Customer	: CU-DAR001 Dart Helicopters Services		Drawing Name	: OUTER FWD SADDLE	
Job Number	: 28079		Part Number	: D5951	
Estimate Number	: 11076		Drawing Number	: D5951 REV A	
P.O. Number	: N/A		Project Number	: N/A	
This Issue	: 8/1/2006 S.O. No. N/A		Drawing Revision	: A	
Prsh Rev.	: NC		Material	: N/A	
First Issue	: N/A		Due Date	: 8/31/2006 Qty: 4 Um: Each	
Previous Run	: N/A				
Written By	: <i>[Signature]</i>				
Checked & Approved By	: <i>[Signature]</i> 06-08-01				
Comment	: Est Rev:E Re-Format 05-11-29 JLM

DART AEROSPACE LTD		Work Order:	28079
Description: Outer Fwd Saddle		Part Number:	D5951
Inspection Dwg: D5951 Rev. A		Page 1 of 1

DESIGN <i>BW</i>	DRAWN BY <i>BW</i>	DART AEROSPACE LTD VICTORIA INTERNATIONAL AIRPORT, CANADA	
CHECKED <i>DMY</i>	APPROVED <i>BW</i>	DRAWING NO. D5951	REV. A SHEET 1 OF 1
DATE 97.05.06		TITLE OUTER FWD SADDLE	SCALE

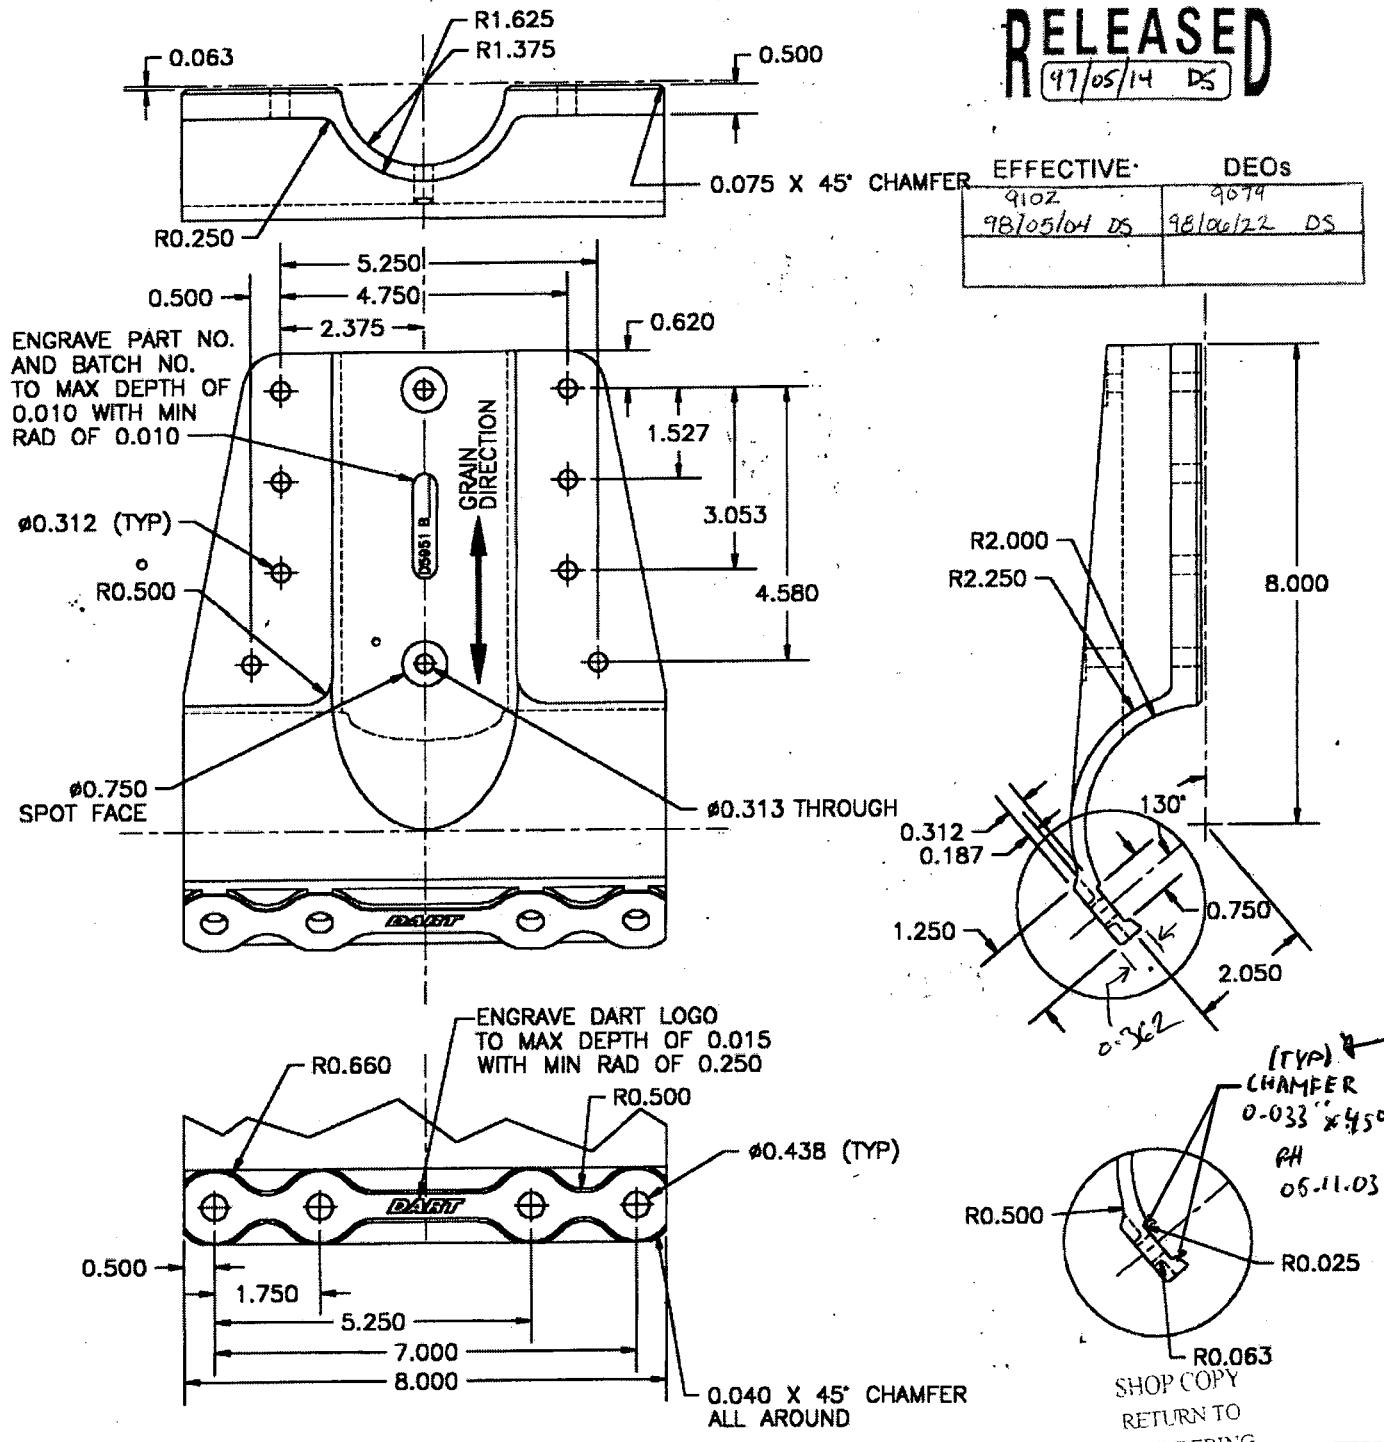
W/O:		WORK ORDER CHANGES						
DATE	STEP	PROCEDURE CHANGE	By	Date	Qty	Approval Mfg / Design Mgr	Approval QC Inspector	
06.11.03	2	CHAMFER 0.033 x 45° WAS ADDED AND CALLED ⑤. SIMILAR TO D2571. SEE ATTACHED	PH 06.11.03

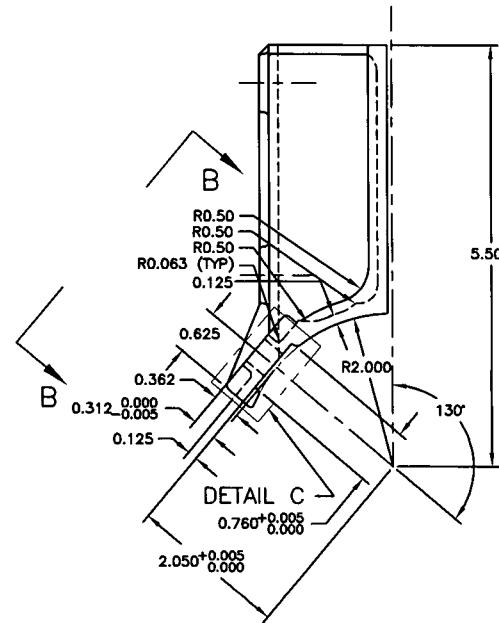
Last year we made a change to the ridges on the 205 saddles (we made a 0.033" X 45 degree chamfer) which I've attached.

Production is making a run of the extended high gear saddles D5951/D5953/D5955/D5957. Can the changes made to the 205 saddles be applied to the x-tended high gear saddles?

The extended high gear goes onto the same D205-634 skidtubes

Chris Bell is currently updating the D5951/D5953/D5955/D5957 saddles and if this change is acceptable, we will add it in

This change is acceptable to me.

DESIGN	DRAWN BY	DART AEROSPACE LTD.	
DS	PH	HANSCOMB, ONTARIO, CANADA	
CHECKED	APPROVED	DRAWING NO.	REV. E
		D2574	SHEET 1 OF 1
DATE	TITLE	SCALE	
05.07.13	INNER AFT SADDLE	2:3

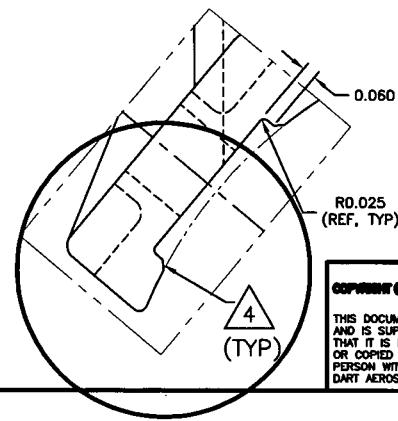
- 1 ENGRAVE PART AND BATCH NUMBER IN THIS AREA TO MAX DEPTH OF 0.010
- 2 CHAMFER 0.063" x 45° AROUND THIS SURFACE (TYPICAL 2 PLACES)
- 3 CHAMFER 0.063 x 45° ALL AROUND
- 4 CHAMFER 0.033 x 45° (SEE DETAIL C) E
